Tullamarine Landfill
Community Consultation Group

MEETING NOTES

4 March 2021

TLCCG Questions and Answers
Tullamarine Landfill Aftercare
Environment Audit
1 July 2018 to 30 June 2019

Question No. 1

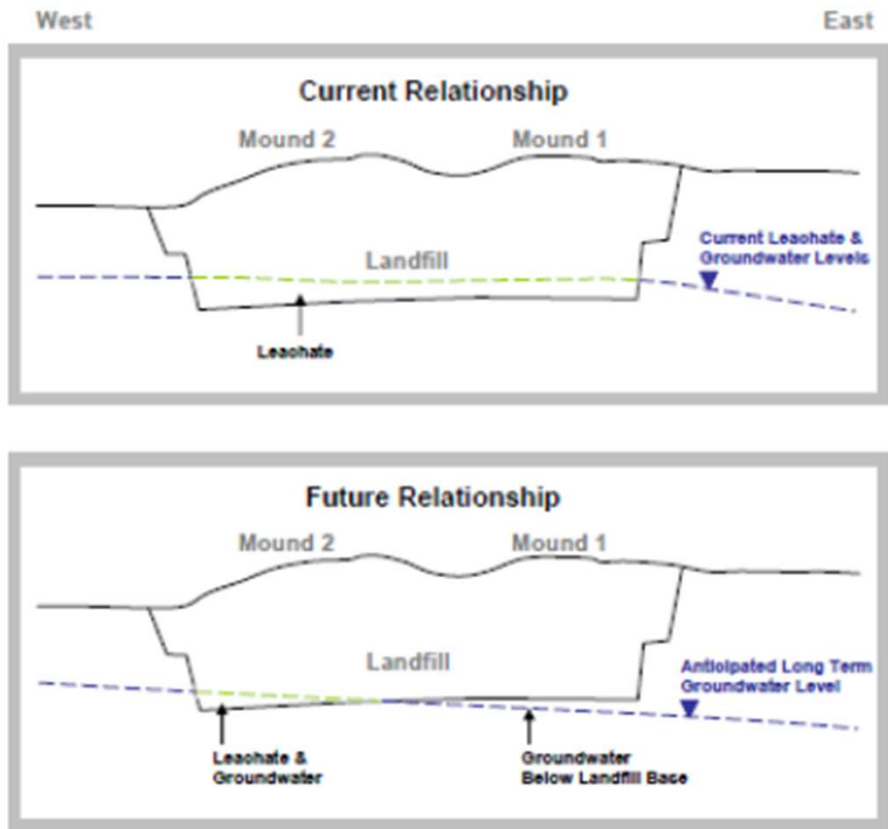
Could the Auditor please elaborate on how she concluded that the set leachate level was unachievable? What is the new level set in the 28/2/21 PCMP? Can you offer any reason why this “impossible to achieve” level was not noticed before?

- The set leachate level of 86.95 m AHD is unachievable because:
 - The base of the waste in Mound 1 and Mound 2 sits at approx. 88 AHD (1.05 m above the set leachate target level).
 - Base of waste in Mound 3 is approx. 92 m AHD (5.05 m above the set leachate target level). Mound 3 received solid waste only, and is reported to be dry i.e. there is no “leachate” in Mound 3.
 - The historical (pre-landfilling) groundwater elevation within Mound 2 is approx. 89 m AHD (2.05 m above the set leachate target level). Continuous extraction of leachate and groundwater would be required within Mound 2, indefinitely, to draw the leachate down to 86.95 m AHD.
 - The historical (pre-landfilling) groundwater elevation within Mound 1 is approx. 87 m AHD.
 - Refer to the following slide.

Reference - Table - 10-1: Landfill Gas Perimeter Bore Groups (original wells) - page 105 - (p 121 of 176)

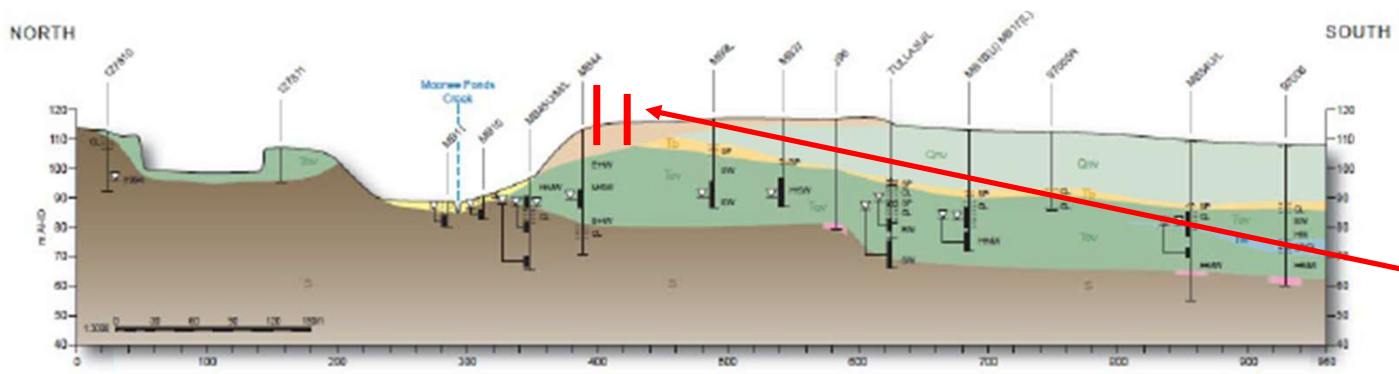
- ***It is presumed the heading FILL in the table refers to soil placed between the finished cap and the surrounding undisturbed ground. Is this correct? (14)***

Refer to the following slide.
